Sheet No. C0.0

Project Title:
EAST TOWN CROSSING PHASE 1

Project No.
2230752
Issue Set & Date:
PERMIT SUBMITTAL
11/20/2023

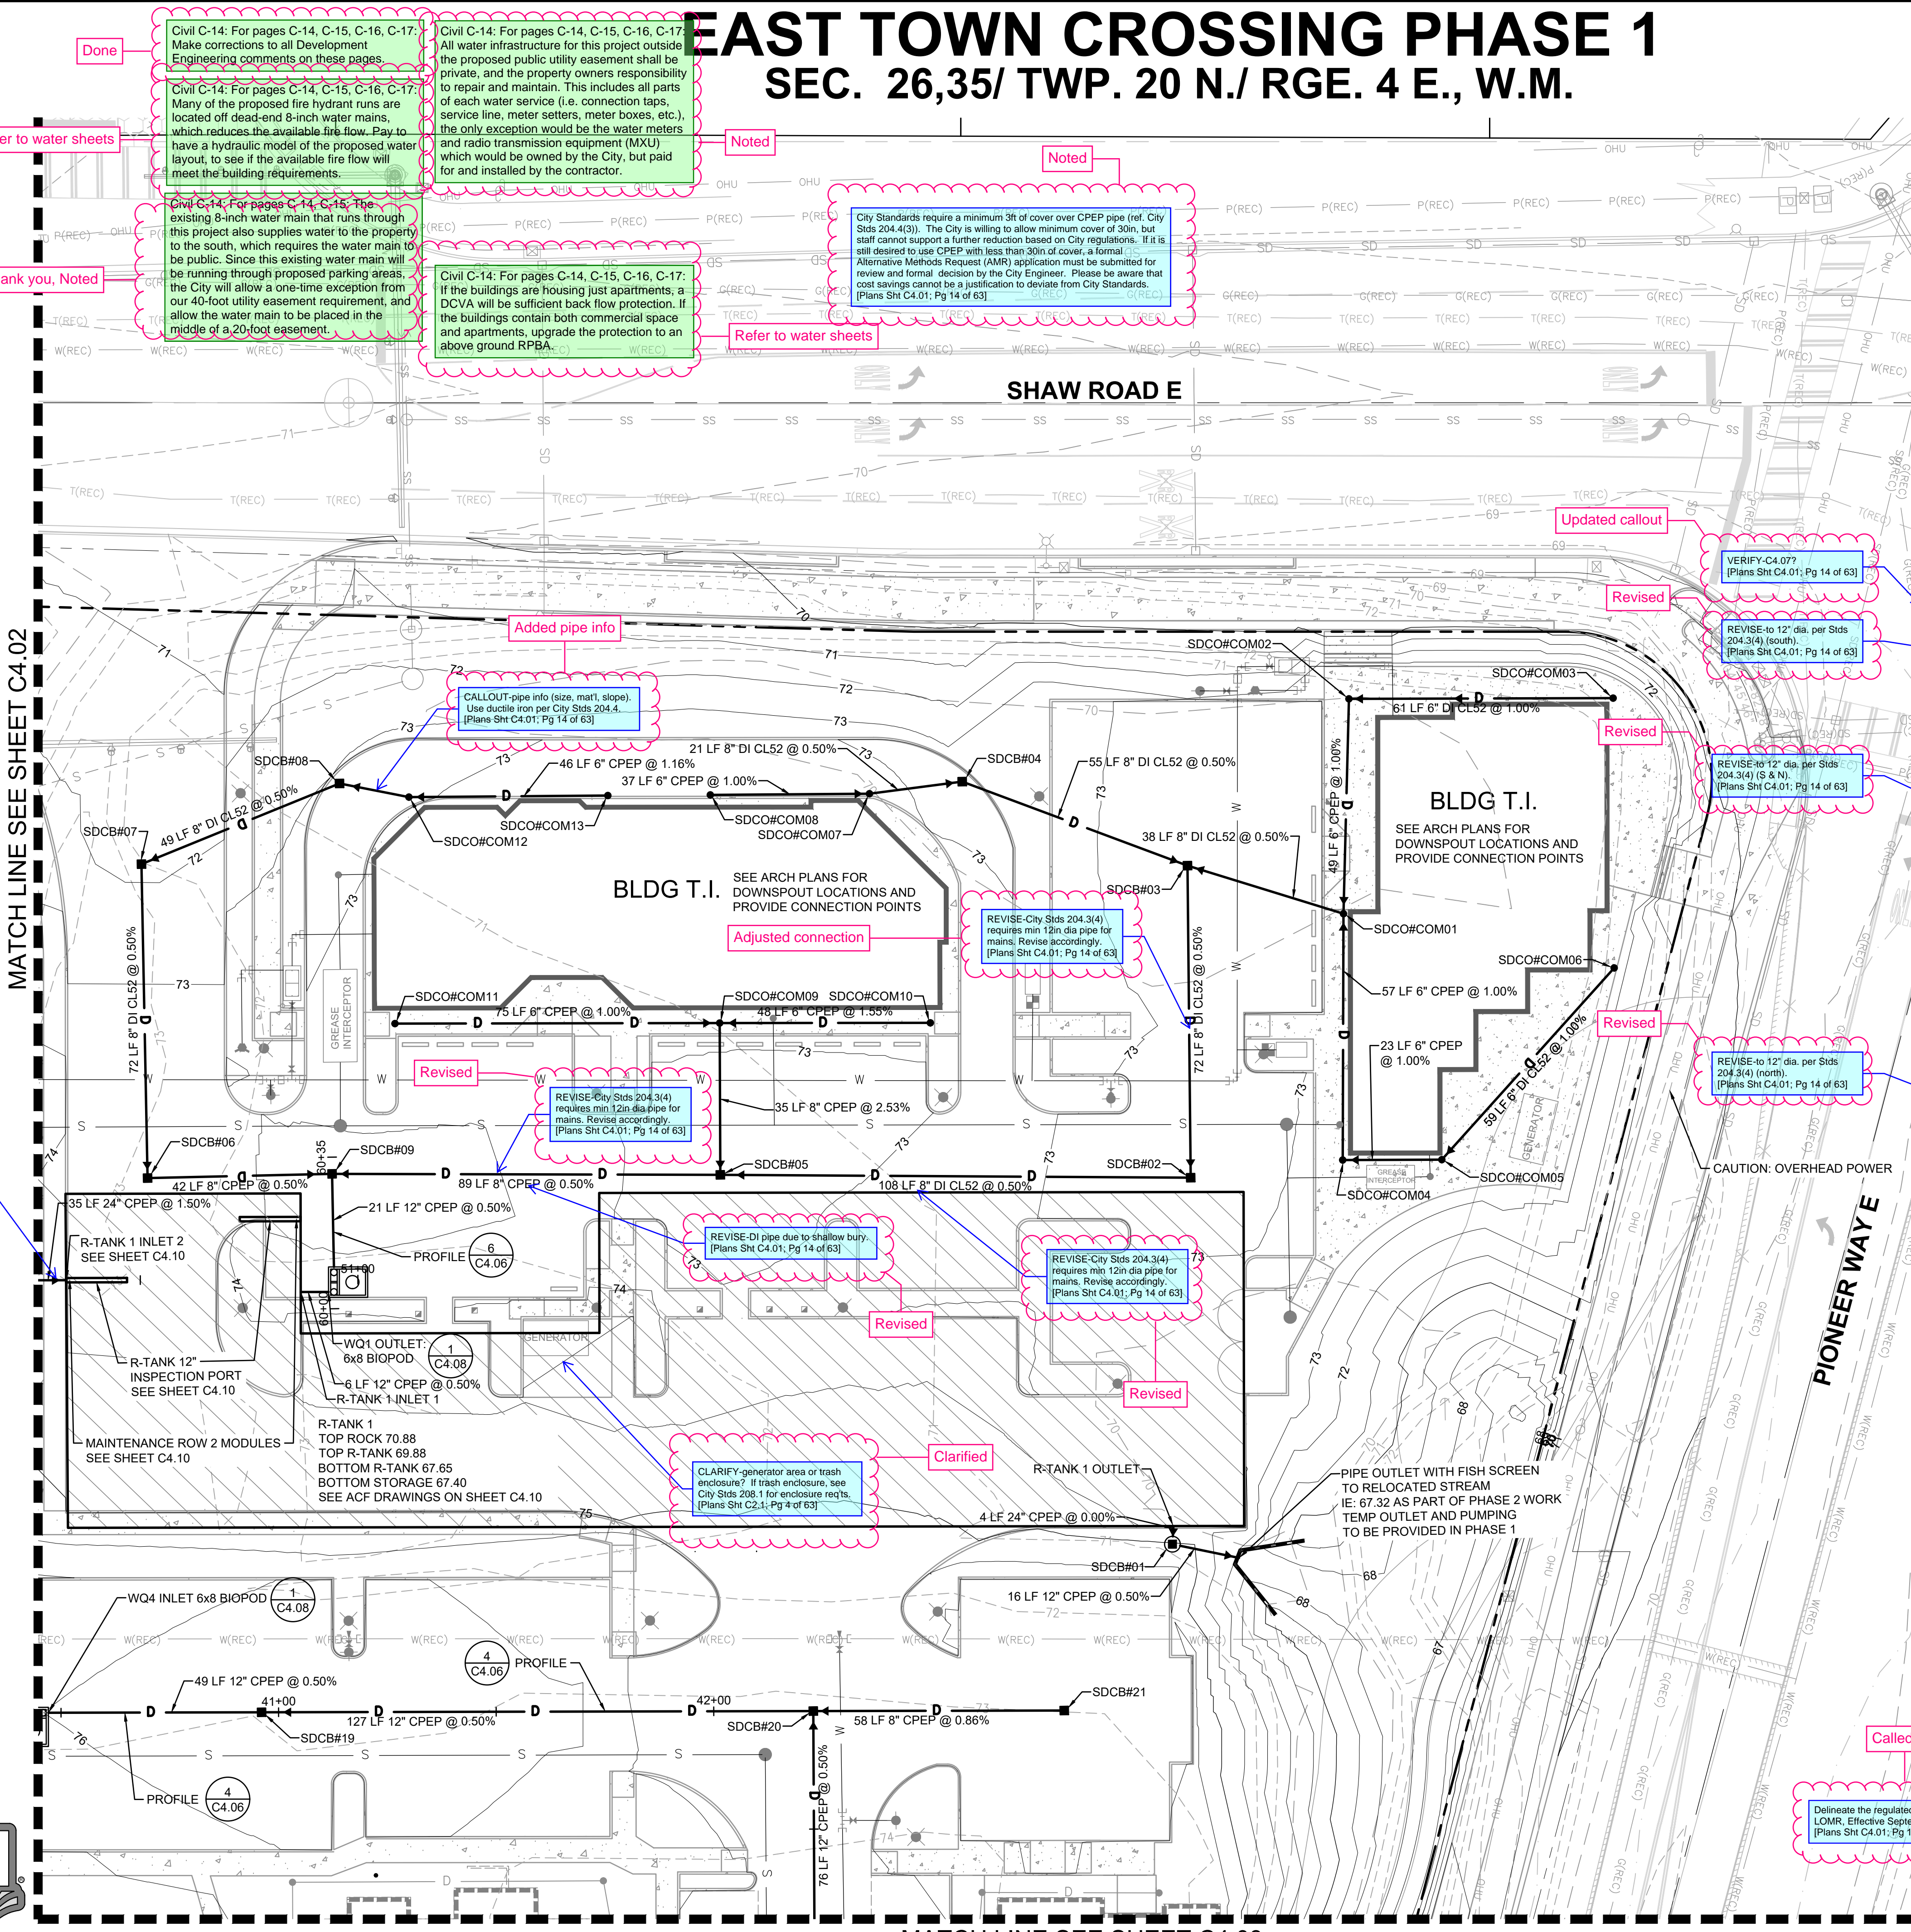
Verified
VERIFY-Profile 5/CA.06 (and 6/C4.06)?
[Plans Sht C4.01; Pg 14 of 63]

Noted
City Standards require a minimum 3ft of cover over CPEP pipe (ref. City Shts 204.4(3)). The City is willing to allow minimum cover of 30in, but still cannot support a further reduction based on City regulations. If it is still desired to use CPEP with less than 30in of cover, a formal Alternative Methods Request (AMR) application must be submitted for review and formal decision by the City Engineer. Please be aware that cost savings cannot be a justification to deviate from City Standards. [Plans Sht C4.01; Pg 14 of 63]

ADD-WQ Rim and inlet elevation info.
[Plans Sht C4.01; Pg 14 of 63]

Updated sheet callout
VERIFY-Sheet callout (C4.07)?
[Plans Sht C4.01; Pg 14 of 63]

Called out
Delineate the regulated floodplain per the LOMR, Effective September 8, 2022.
[Plans Sht C4.01; Pg 14 of 63]

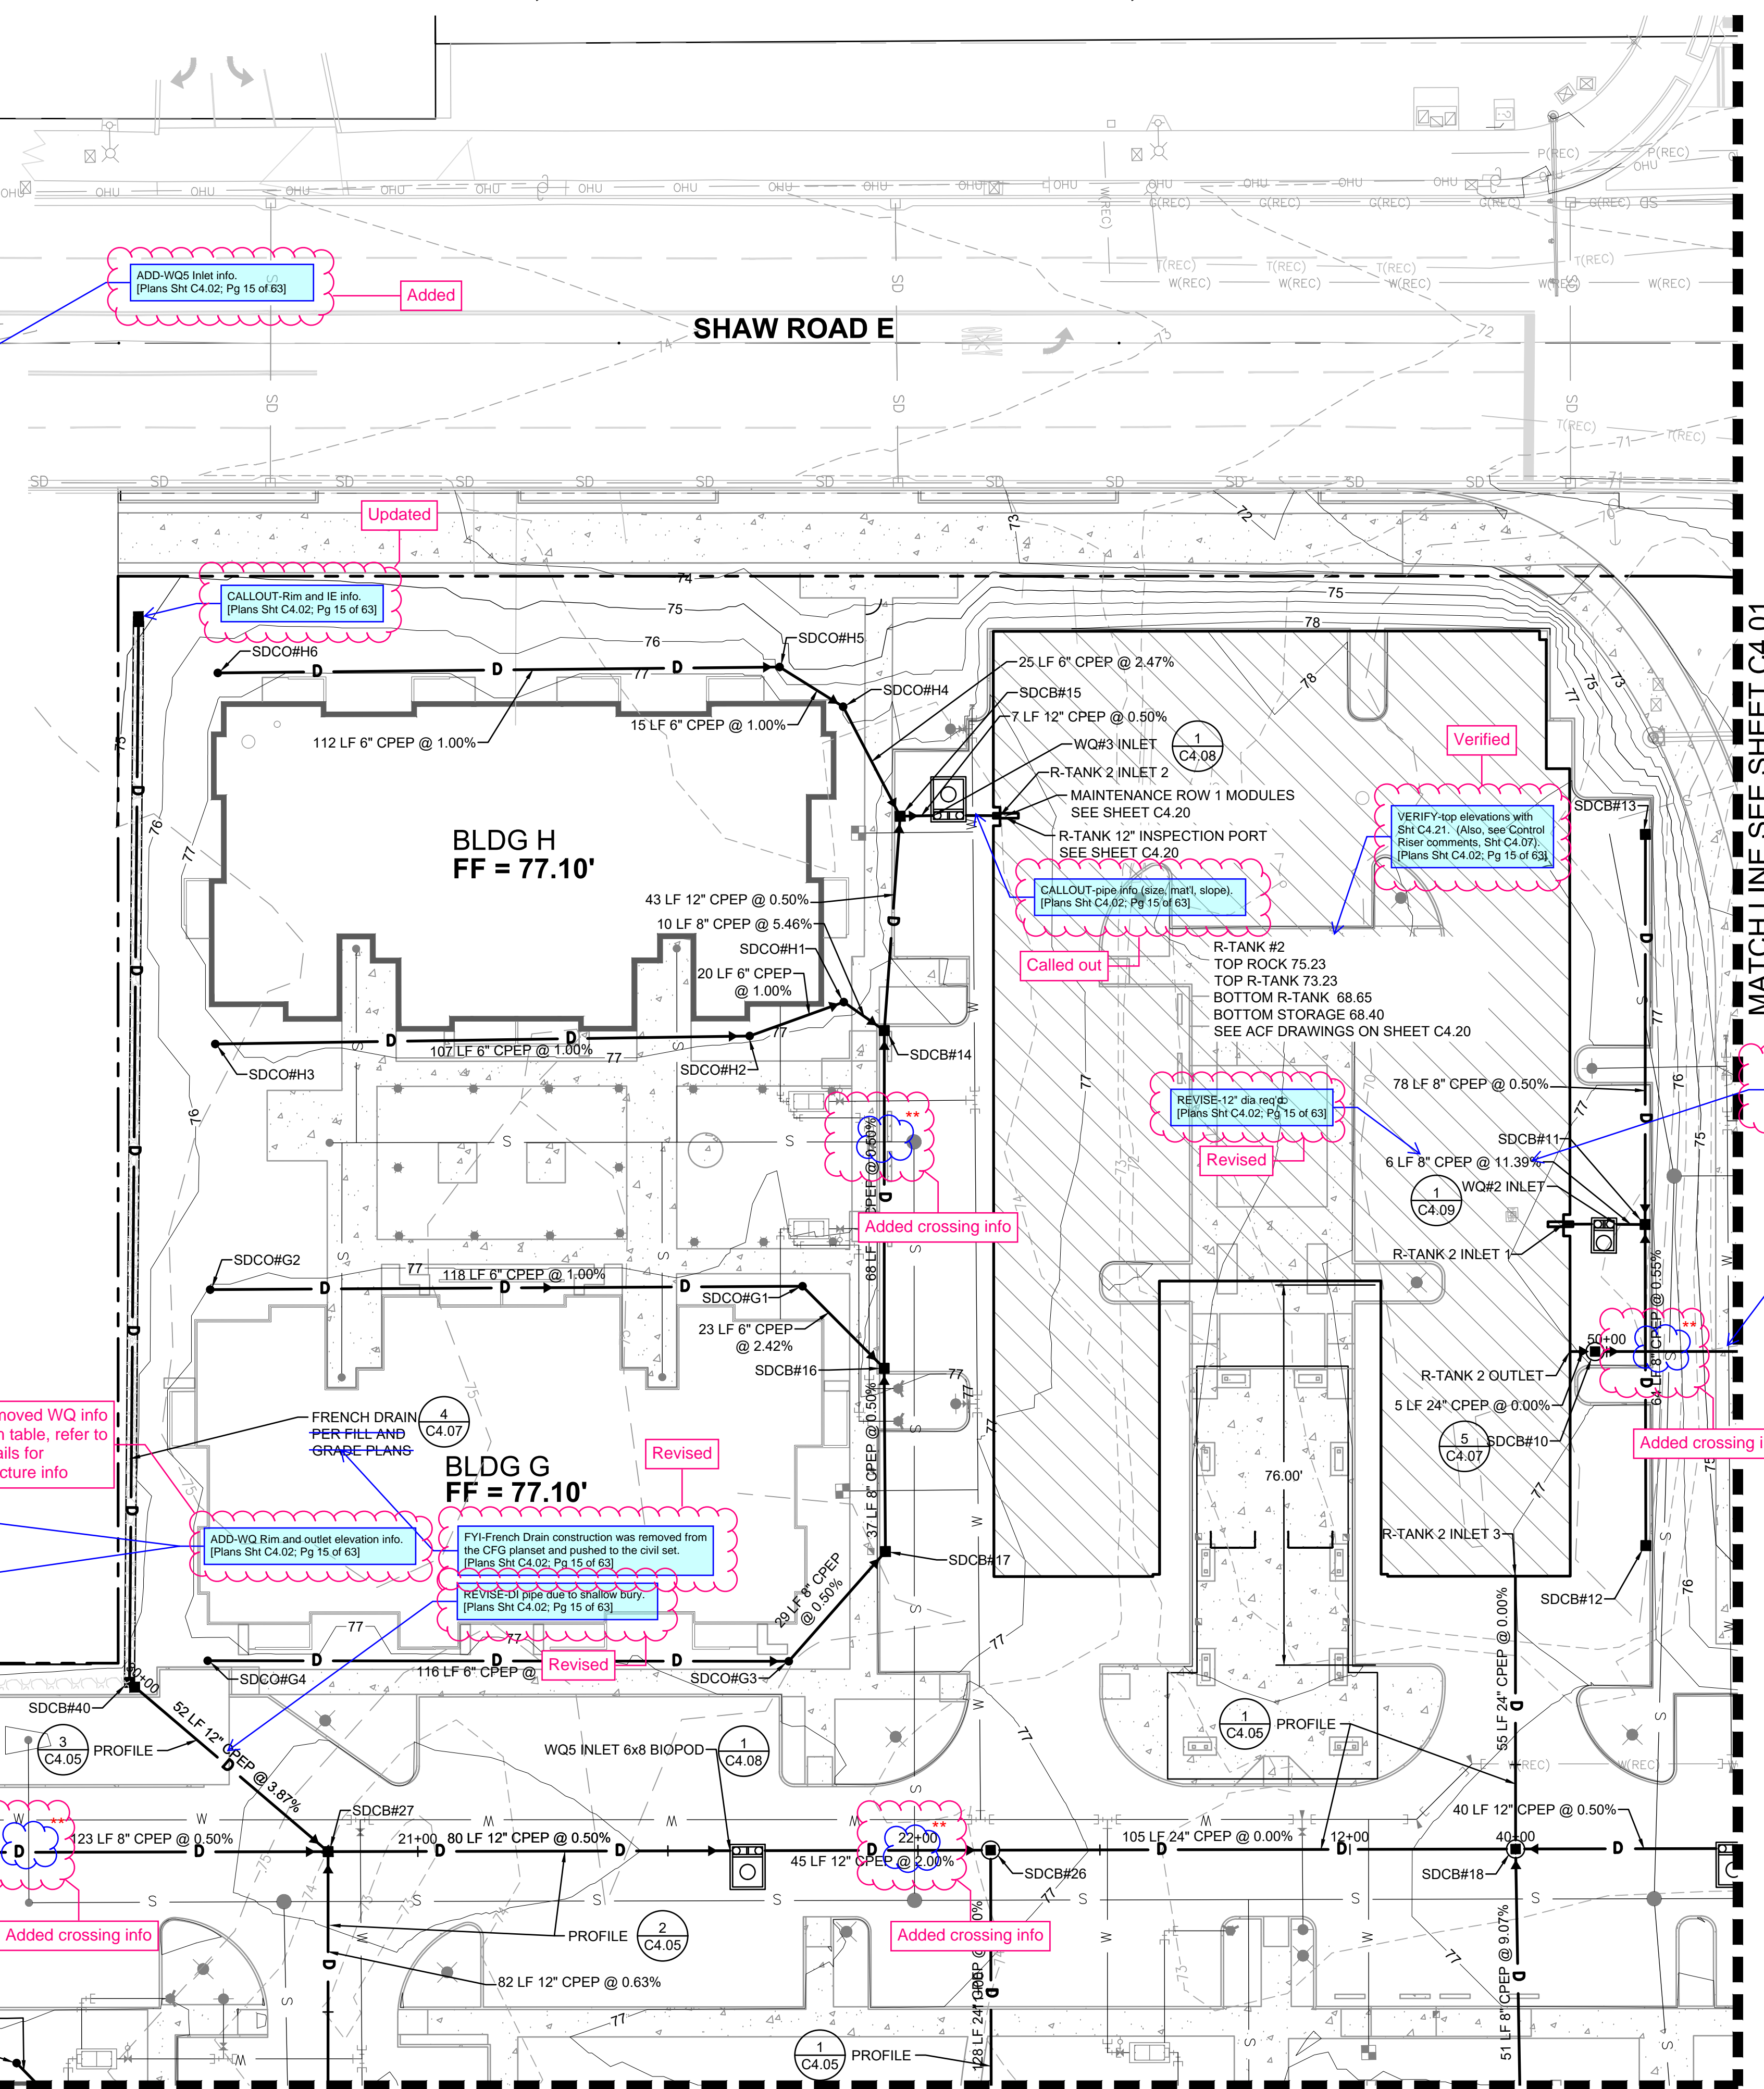
VERIFY-C4.07? [Plans Sht C4.02; Pg 15 of 63]
Updated callout

VERIFY-Solid locking lid for WQ purposes? [Plans Sht C4.02; Pg 15 of 63]

ADD-WQ Rim and outlet elevation info. [Plans Sht C4.02; Pg 15 of 63]

FYI-French Drain construction was removed from the CFG planset and pushed to the civil set. [Plans Sht C4.02; Pg 15 of 63]

REVISE-D1 pipe due to shallow bury. [Plans Sht C4.02; Pg 15 of 63]

CALLOUT-pipe info (size, mat'l, slope). [Plans Sht C4.02; Pg 15 of 63]

VERIFY-Top elevations with Sht C4.21. (Also, see Control Riser comments, Sht C4.07). [Plans Sht C4.02; Pg 15 of 63]

VERIFY-pipe slope w/ IEs. [Plans Sht C4.02; Pg 15 of 63]

VERIFY-Profile 5/C4.06 (and 6/C4.06)? [Plans Sht C4.02; Pg 15 of 63]
